**SITE PLAN REVIEW TECHNICAL ADVISORY COMMITTEE
PORTSMOUTH, NEW HAMPSHIRE**

**RE: Response Letter – Peer Review
635 Sagamore Ave, Portsmouth, NH
Tax Map 222, Lot 19
JBE Project No. 18134.1**

Project: **"LUSTER CLUSTER" 635 SAGAMORE AVE., PORTSMOUTH, NH**

LINED STONE DRIP EDGE DETAIL

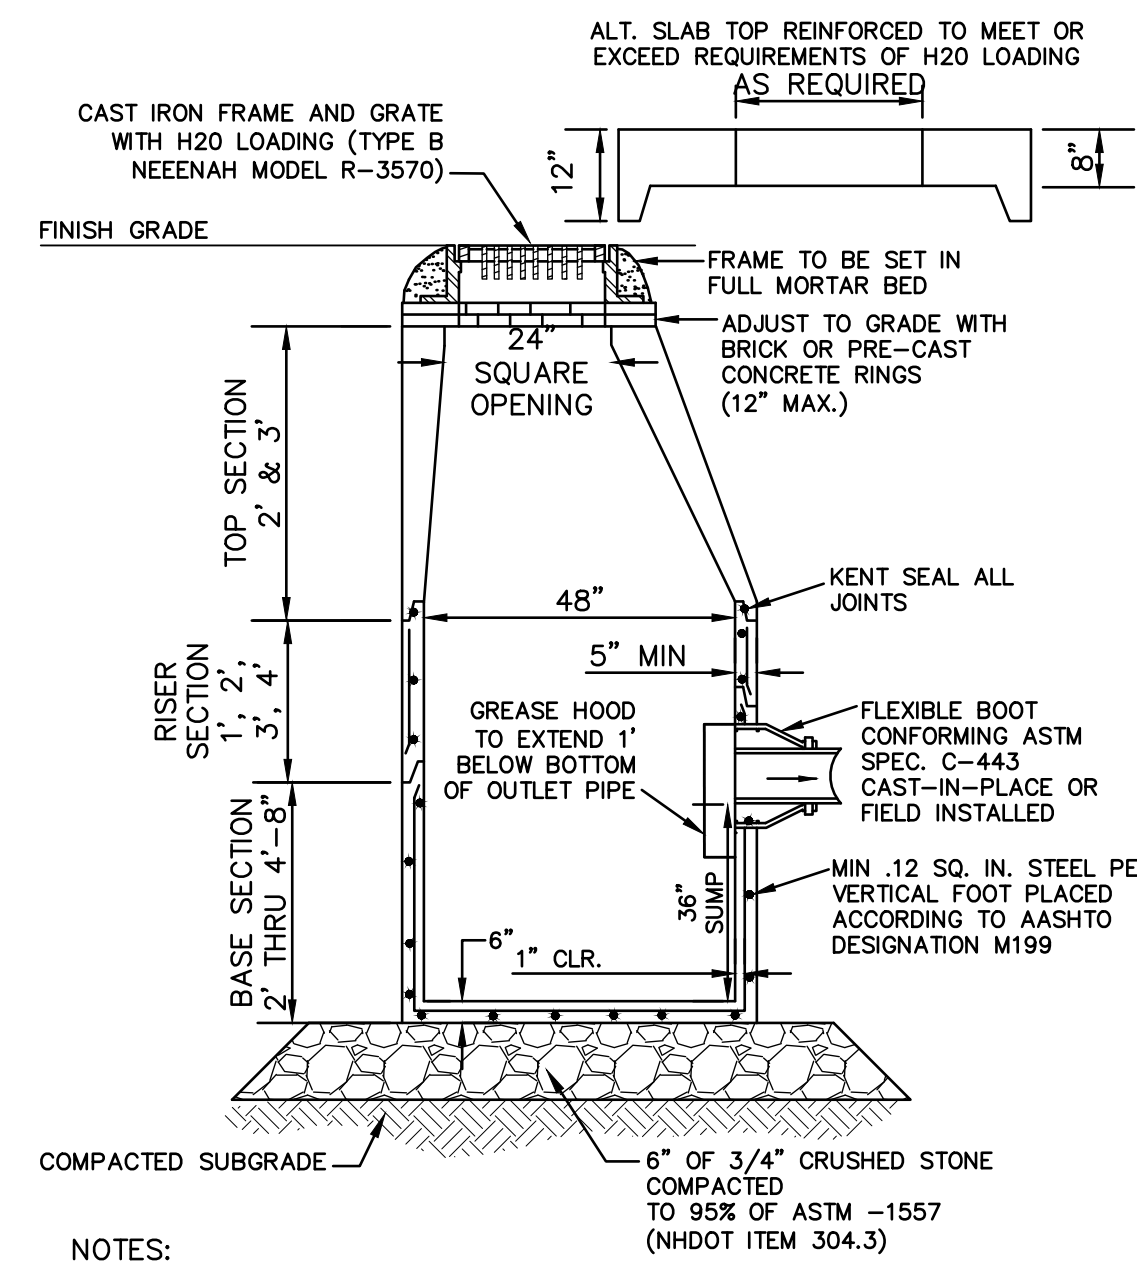
8. Units 3 and 4 are described as being walk out basements. It is presumed that units 3 and 4 will not have perimeter drains as the Designer is proposing to utilize stone drip edges for infiltration. The foundation/stone drip edge detail indicates that there are no perimeter drains for those units. It is unclear if units 1 and 2 will have basements and perimeter drains. Outlets for perimeter drains should be depicted on the plans.

RESPONSE: The stone drip edges are now proposed to be lined and underdrained to prevent infiltration to the perimeter drain. We are instead placing 3' of stone underneath the decks for Units 3 and 4 and routing the drip edge underdrains into the stone underneath the decks in order to infiltrate the roof water. This is not required for flow or volume reduction, but the stone is proposed for infiltration in order to meet the City of Portsmouth's stormwater pollutant removal requirement (Site Plan Review Regulations 7.6.2.1(a)).

All four units will need to have perimeter drains. However, foundation drain locations are typically determined by the building contractor and not shown on proposed development plans. It should be noted that the basements for the back two units are going to be almost entirely above the seasonal high water table.
